APPLICATION FOR VARIANCE OR APPEAL
Jonathan Ochshorn
May 28, 2013

APPLICATION FOR VARIANCE OR APPEAL

PETITION NO:
2013-0250

PROPERTY City Town Village of Ithaca County of Tompkins
Address 943 University Avenue, Ithaca, NY 14853

Figure 2. Egress from Milstein Hall crit space (a) as it actually is; and (b) with the room hypothetically extended into the corridor. Drawing by Jonathan Ochshorn based on Milstein Hall plans.

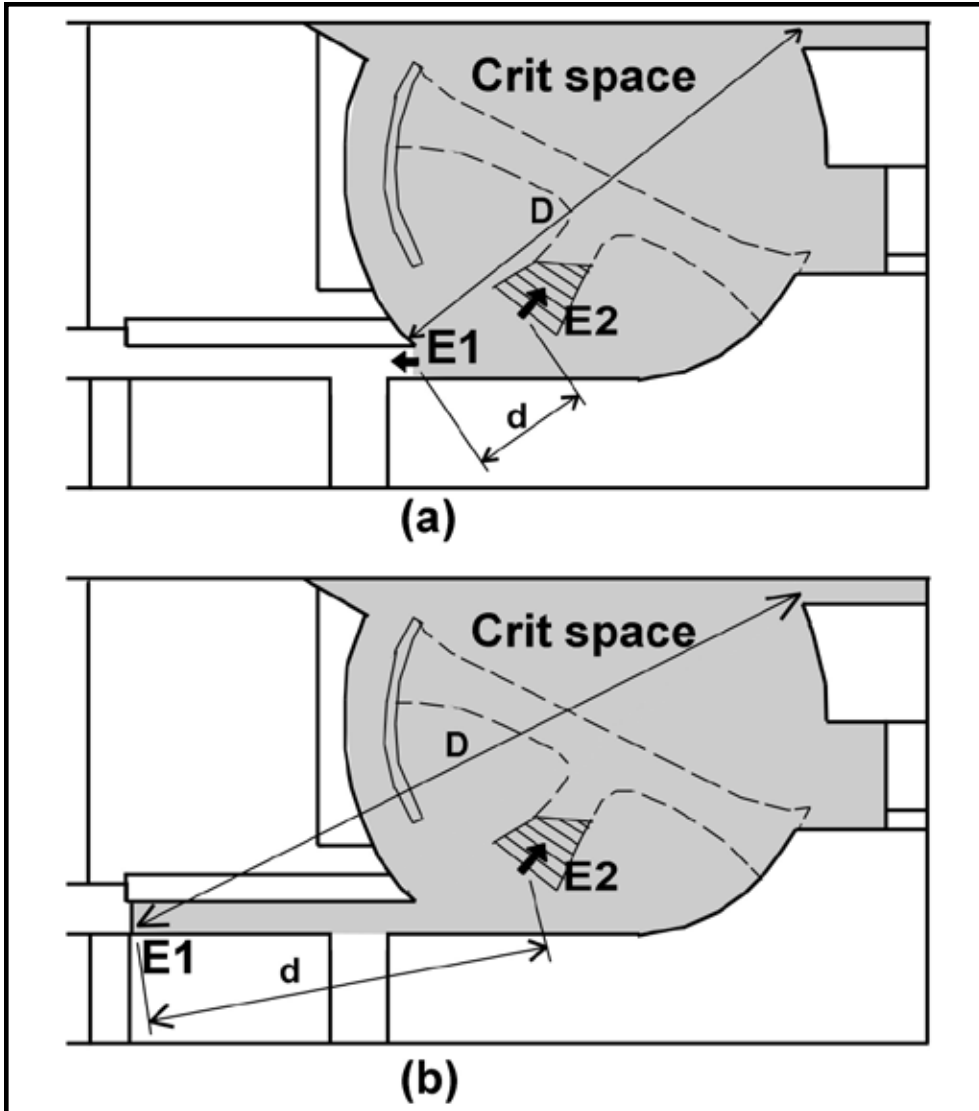
However, even assuming two exits are appropriate, these two exits must be “placed a distance apart equal to not less than one half [or one third for this sprinklered space, per exception 2] of the length of the maximum overall diagonal dimension of the building or area to be served” (2002 Building Code of NYS, Table 1004.2.2.1). The exits from this space do not comply with this separation requirement. Rather, the two exits—the first opens to a corridor and the second consists of a stair leading to an overhead bridge—are immediately adjacent to each other without adequate separation distance (Figure 2a).

I was first informed by Gary Wilhelm, Project Director at Cornell, that egress compliance is achieved by considering the corridor leading from the crit room space *to be actually part of the crit room space*, thereby extending the separation distance between the first exit (now “moved” to the far end of the corridor) and the second exit (the stair), as illustrated in Figure 2b.

This explanation violates both the letter and spirit of the exit requirements in the 2002 Building Code of NYS. While an expert Code opinion on this question is not binding on local Code Enforcement Officials, the following opinion, written by Michael W. Giachetti, P.E., Senior Staff Engineer for the International Code Council, does raise substantial doubts about the judgment of those charged with implementing the Milstein Hall project. He stated, in an email to me dated March 5, 2012:

not be satisfied. In your example, including the area of the corridor as part of the “room” does not change the fact that the two paths into the corridor are not remote. As such, including the area of the corridor as part of the “room” does not resolve the problem with remoteness” (emphasis added).

Figure 3. Common path of travel from crit space exceeds 75-foot limit: partitions and furnishings preclude measuring this distance as a single straight line. Drawing by Jonathan Ochshorn based on Milstein Hall plans.

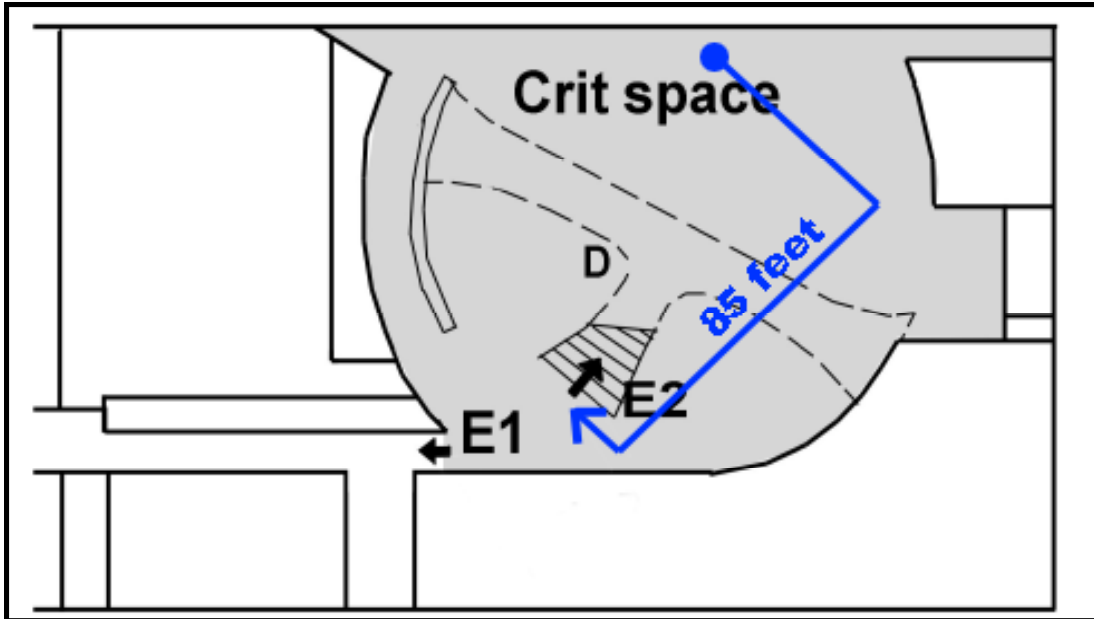
First, this is not what the Building Code requires: the common path of travel limits must be complied with, *and* the two required exits must be separated from each other by a minimum code-specified distance. Meeting one of these requirements does not allow you to violate the other. Second, it is not even true that the 75-foot limit for common path of travel (2002 Building Code of NYS, Section 1004.2.5) is met: see Figure 3. Common path of egress travel is rarely measured “as the crow flies”; rather, the measurement must account for typical placements of chairs, desks, or partitions, as shown in Figure 3. This requirement is discussed in the *Commentary* to the 2009 IBC: “The route must be assumed to be the natural path of travel without obstruction. This commonly results in a rectilinear path similar to what can be experienced in most occupancies, such as a schoolroom or an office with rows of desks [see Figure 1016.1(2)]. The ‘arc’ method, using an ‘as the crow flies’ linear measurement, must be used with caution, as it seldom represents typical floor design and layout and, in most cases, would not be deemed to be the natural, unobstructed path.” Figure 1016.1(2) from the *Commentary* is reproduced below as Figure 4. The permanent partitions in the crit room, not shown in Figure 3, but illustrated in Figure 5, make it absolutely critical that the common path of egress travel accurately reflects the “natural path of travel” around such partitions or chairs.

All three of these code-required provisions—an adequate number of exits, exits placed an adequate distance apart, and common path of egress travel requirements—are not met in this space, making it triply noncompliant and dangerous.

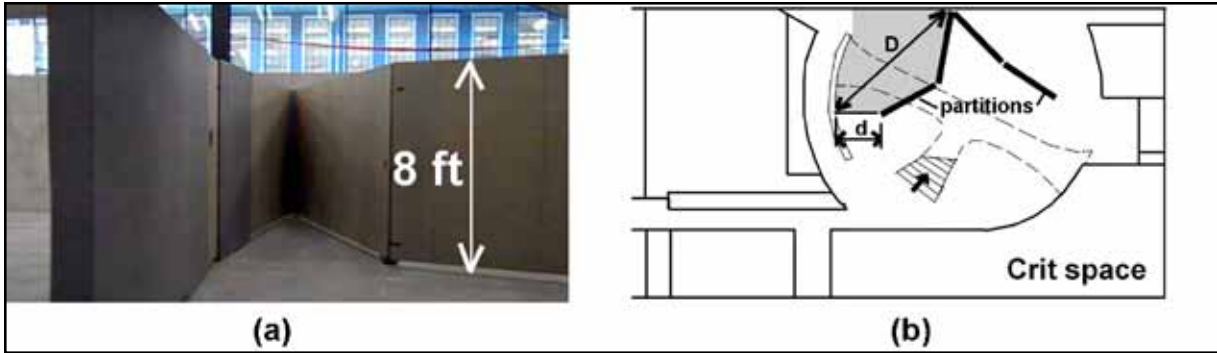
Moreover, the crit room space has been subdivided into several “flexible” spaces with permanent 8-foot high movable partitions. These partitions can be configured in ways that also create assembly rooms, each required to have two separated means of egress. Some configurations create conditions where only a single means of egress is provided even when the calculated occupancy exceeds 50 people (Figure 5).

These partitions are not lightweight dividers equivalent to pieces of furniture. Rather, they are quite substantial—in fact, far more substantial than typical room-dividing partitions—and consist of welded structural-steel frames clad with layers of plywood, Homasote, and felt. They extend a full eight feet above the floor and are permanently fastened to the building's structure. That they can also be moved into positions where they do not create noncompliant spaces is not relevant: the 2002 Building Code of NYS does not permit noncompliant spaces just because they are only noncompliant some of the time. A building must be Code-compliant in *all* of its possible configurations.

of 49; the 2002 Code has a limit of 50]. An alternative remedy would be to add additional, remote, exits from the space, corresponding to the calculated occupancy.

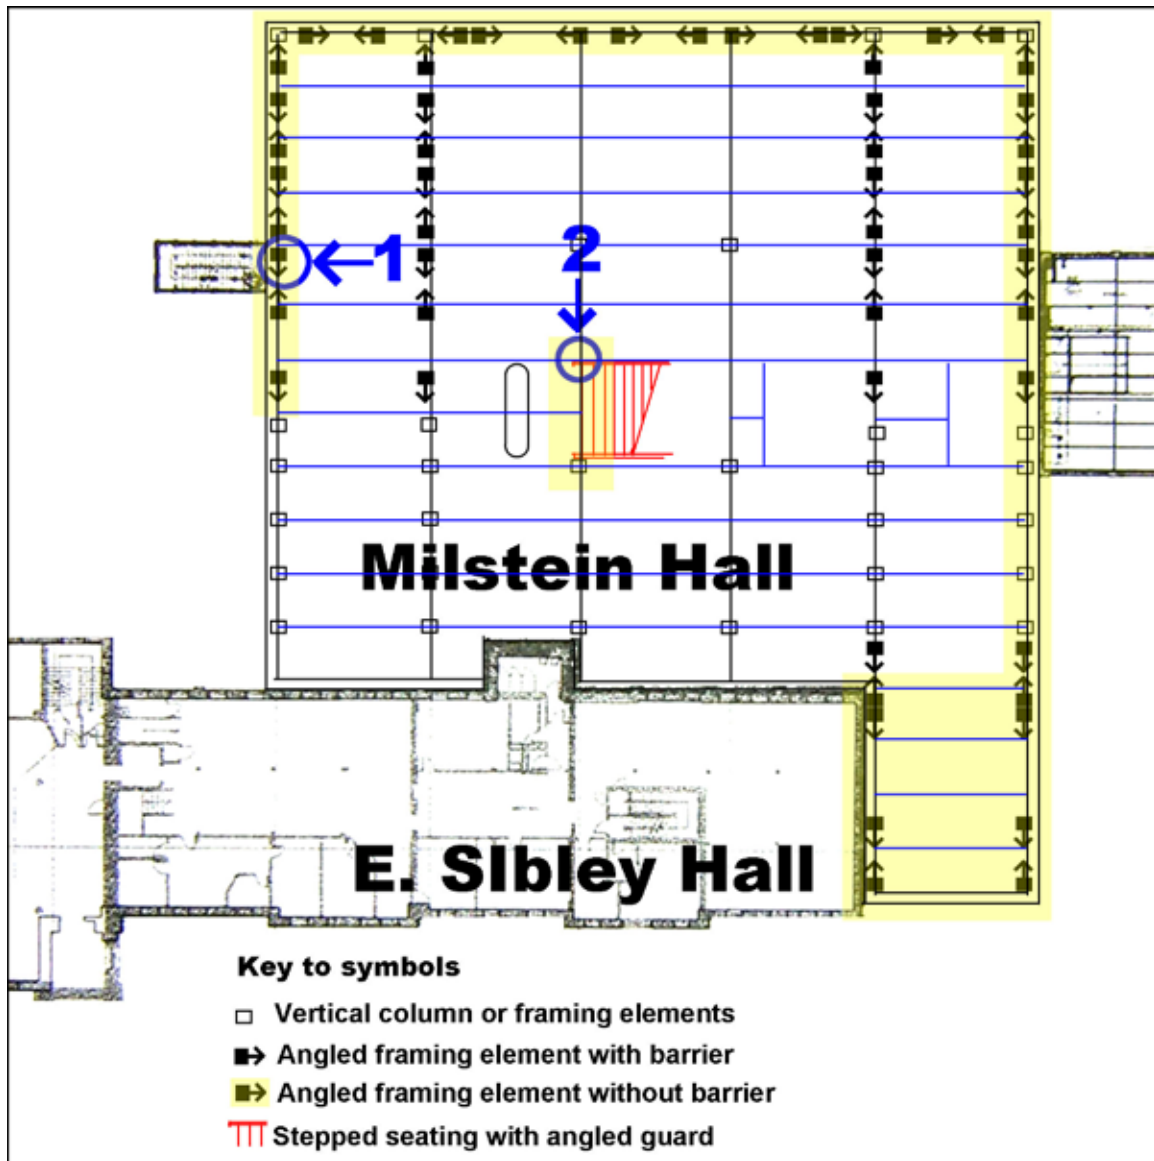
Sections 1003.2.5.1 and 1003.2.5.3 of the 2002 Building Code of NYS specify that protruding objects that reduce headroom below 80 inches or project more than 4 inches horizontally over any walking surface between the heights of 27 and 80 inches are not permitted within the means of egress. Numerous instances of such protruding objects can be found on the second floor (studio level) of Milstein Hall, as shown in Figure 6.

The means of egress is defined in Section 1002 of the 2002 Building Code of NYS as a "continuous and unobstructed path of vertical and horizontal egress travel *from any point*

in a building or structure to a public way" (emphasis added) so all of the aisles and passageways on the second floor plate count as part of the means of egress. Two types of protruding objects are present, as identified in Figure 6, and illustrated in Figures 7 and 8 below: angled framing elements which reduce headroom below 80 inches, and angled stepped seating guards that protrude horizontally more than 4 inches into the egress space.

To remedy this situation, barriers should be placed at all noncompliant angled framing elements and guards.

Figure 7. Typical angled column reducing headroom below 80 inches (labeled #1 in Figure 6). The yellow tone indicates the general area within which a barrier is needed. Photo and annotations by Jonathan Ochshorn.

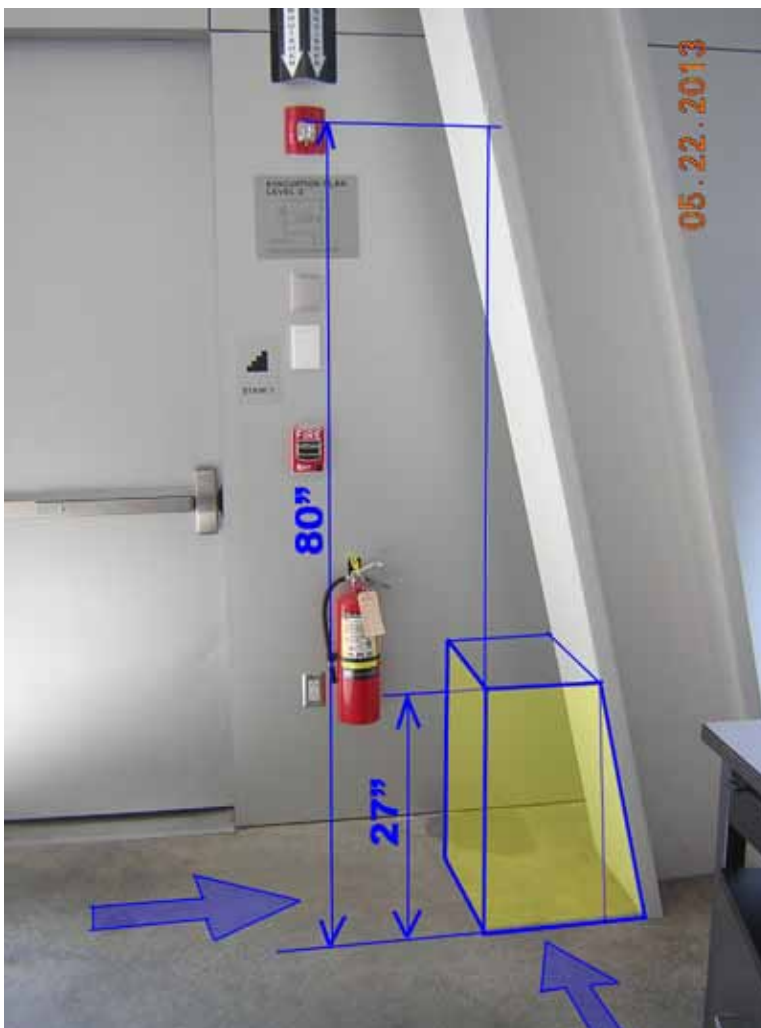
If it is claimed that angled framing elements along the outside edge of the second floor plate are not in the means of egress because they form a boundary to the egress pathway (see, for example, the angled element shown in Figure 7), it should be noted that without a barrier defining this boundary, it remains *invisible* to those with visual impairments, and becomes especially dangerous if the room fills with smoke—precisely the reasons for requiring boundaries around such protrusions.

Figure 9. Second-floor plan: The fire barrier wall width, between Milstein Hall and E. Sibley Hall, is shown in red; openings are shown in blue. The aggregate opening width exceeds 25% of the fire barrier width. Drawing by Jonathan Ochshorn based on Sibley and Milstein Hall plans.

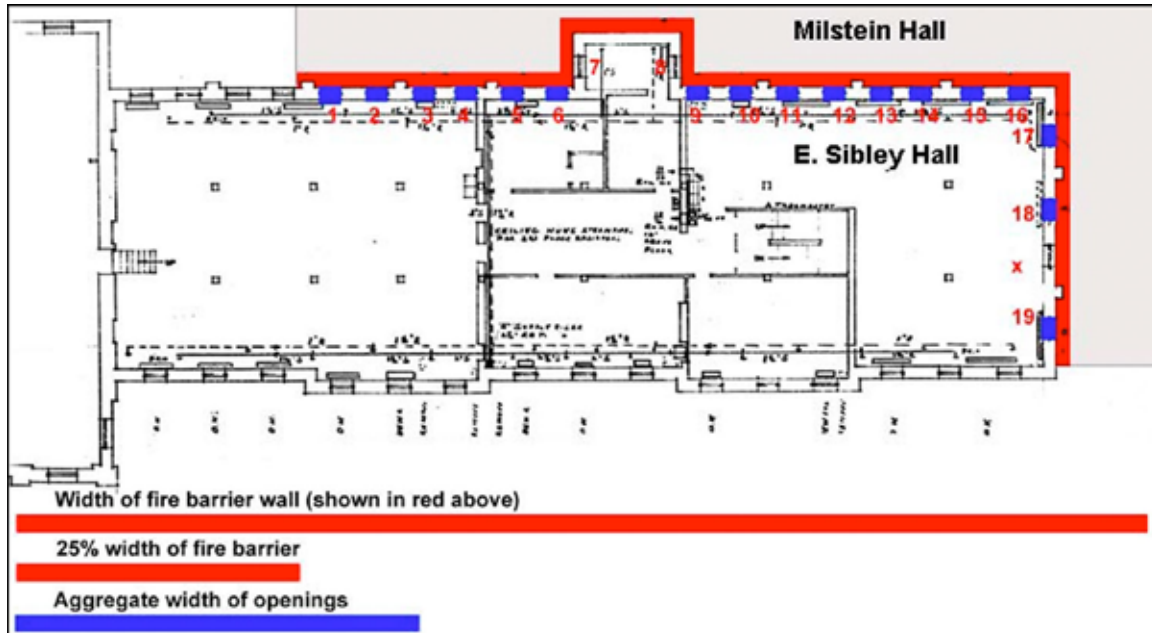
The fire barrier provided between Milstein and Sibley Halls is noncompliant. Section 706.6 of the 2002 Building Code of NYS limits openings in fire barriers to a maximum aggregate width of 25 percent of the length of the wall. The opening width in the fire barrier between Milstein and Sibley Halls exceeds 25 percent and is therefore noncompliant, as shown in Figure 9.

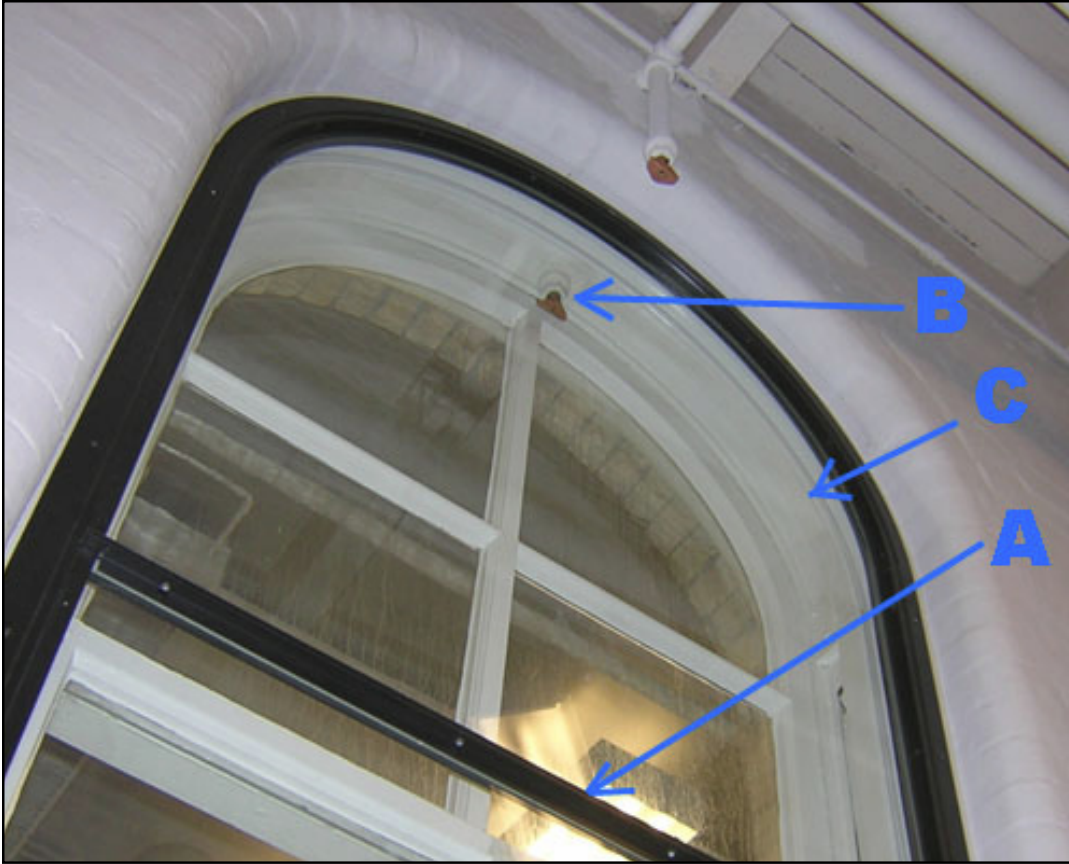
Gary Wilhelm, Project Director at Cornell, suggested to me that Tyco 5.6 K-Factor Model WS Specific Application Window Sprinklers could be provided to create a compliant fire barrier (Section 706.6, exception 3, 2002 Building Code of NYS). These sprinklers were, in fact, later installed. However, the Tyco product specifications indicate that this system is inappropriate for this application—i.e., not tested in accordance with ASTM E 119—for the following three reasons, illustrated in Figure 10:

- a) Such window sprinklers are *not* listed to protect windows when intermediate horizontal mullions are present (the Tyco prohibition against horizontal mullions is reproduced in Figure 11). In this Sibley-Milstein Hall application, horizontal mullions *are* present in the fire-rated glazing.
- b) The sprinklers cannot be sandwiched between new fire-rated glazing and existing windows, as they are in this application.
- c) All combustible materials must be kept two inches from the front face of the glass. In this application, wooden window frames are closer than two inches from the glass.

Figure 13. Noncompliant mezzanine: Ground floor lobby-bridge (left) exceeds one-third area of crit room space at lower level (right). Drawing by Jonathan Ochshorn; plans based on Milstein Hall drawings placed online by Cornell University; areas are approximate, based on dimensions scaled from plans.

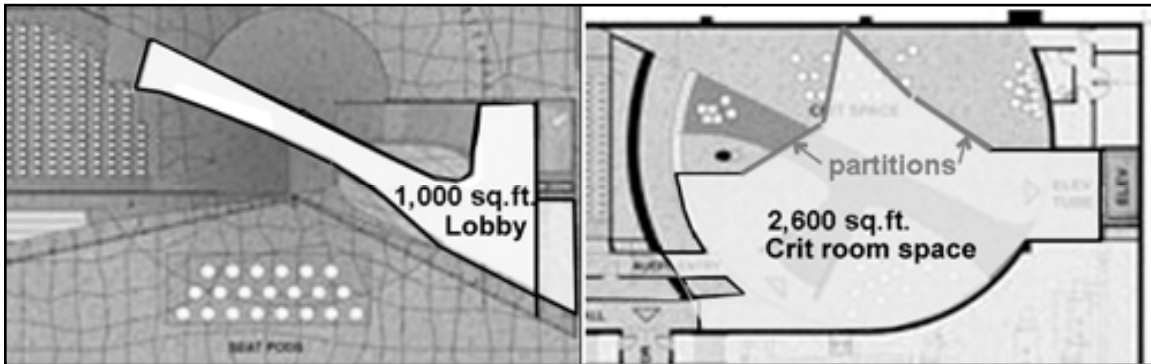
The movable partitions in the lower-level crit space of Milstein Hall create separate and smaller rooms within what was a single space, and therefore call into question the designation of the ground-floor lobby as a mezzanine (Figure 13). The lobby floor area is not less than one-third the area of smaller spaces that can be configured using the movable partitions (exactly what room the lobby is "in" when the movable partitions are deployed is difficult to determine), so the lobby appears to no longer satisfy the criteria for designation as a mezzanine.

If these partitions were permanently fastened to the floor within the domed space of the crit room, there is little question that they would be considered separate spaces or rooms. That they are permanent, but not fixed-in-place partitions (i.e., they are movable) should not alter this conclusion: they are constructed with heavy steel frames, studs, and plywood, and extend from the floor to a height of 8 feet; much like the construction of fixed-in-place partitions.

In either case—whether the lobby is judged to be *outside* the crit room space; or whether the size of the lobby is determined to exceed the size limit for mezzanines based on the floor area of the *partitioned* crit room—the lobby becomes a “story” rather than a mezzanine, and therefore at least two aspects of the building become noncompliant with the 2002 Building Code of NYS: a) unprotected floor openings now connect three, rather than two, stories in Milstein Hall in violation of Section 707; and b) required men’s and women’s rooms become two stories distant from the main studio floor level, in violation of Section 2902.4.1.

Figure 14. Approximate second-floor areas Halls (adapted from Cornell’s Milstein Hall web site by Jonathan Ochshorn)

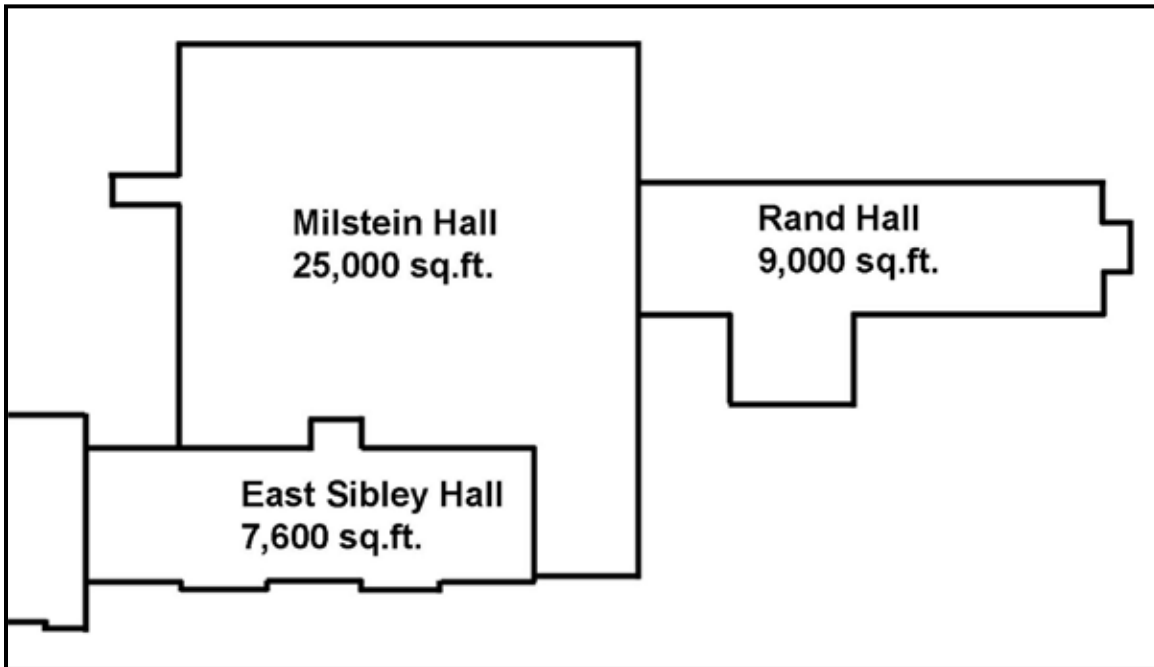
Milstein Hall is noncompliant under the 2002 Building Code of New York, since the total floor area of the combined buildings (Milstein-Sibley-Rand Halls) exceeds floor area limits based on Table 503 (Figure 14). Only by separating Milstein Hall from Sibley Hall with a *fire wall* or upgrading Sibley Hall to Type III-A construction would the floor areas be compliant.

The maximum allowable building area, per floor, tabulated in Table 503 of the 2002 Building Code of NYS is 6,000 square feet for an A-3 occupancy with V-B construction type (this construction type is determined by the construction of Sibley Hall). Adding 12,000 square feet for sprinklers and 4,500 square feet for frontage (the *maximum possible* allowance), we get a maximum allowable per floor area of 22,500 square feet—far less than the actual combined second-floor area. Assuming a Group B occupancy with a tabular maximum per floor area of 9,000 square feet, the total allowable per-floor area becomes 33,750 square feet, still far less than the actual combined second-floor area of this project.
